APPLICATION NO.	FILING DATE	FIRST NAMED INVENTOR	ATTORNEY DOCKET NO.	CONFIRMATION NO.
10/579,852	05/17/2006	Dietmar Van Der Linden	R.307220	8908
2119 7590 11/05/2009 RONALD E. GREIGG GREIGG & GREIGG P.L.L.C. 1423 POWHATAN STREET, UNIT ONE ALEXANDRIA, VA 22314				
EXAMINER				
MCALISTER, WILLIAM M				
ART UNIT		PAPER NUMBER		
3753				
MAIL DATE		DELIVERY MODE		
11/05/2009		PAPER

### Office Action Summary

**DETAILED ACTION**

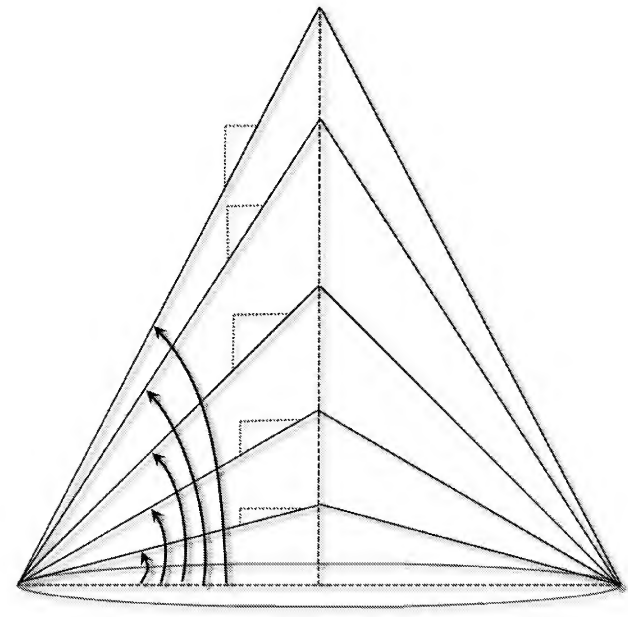
With reference to the figure below, note that as a cone's slope increases, the cone's base angle increases. A cone's base angle is considered a "cone angle" as claimed, under the broadest reasonable interpretation of this term.

Regarding claim 8, Talaski discloses (see FIG 8) a valve with a bore (14') of increasing diameter from left to right. Talaski discloses at least 5 conical surfaces (40) located along this bore, each formed of a section of a cone (see ¶ [0027]) which has a cone base angle (inherently, as illustrated above). In the direction of increasing bore diameter (from left to right, FIG 8), Talaski discloses these cone sections to have increasing cone slopes and therefore increasing cone base angles.
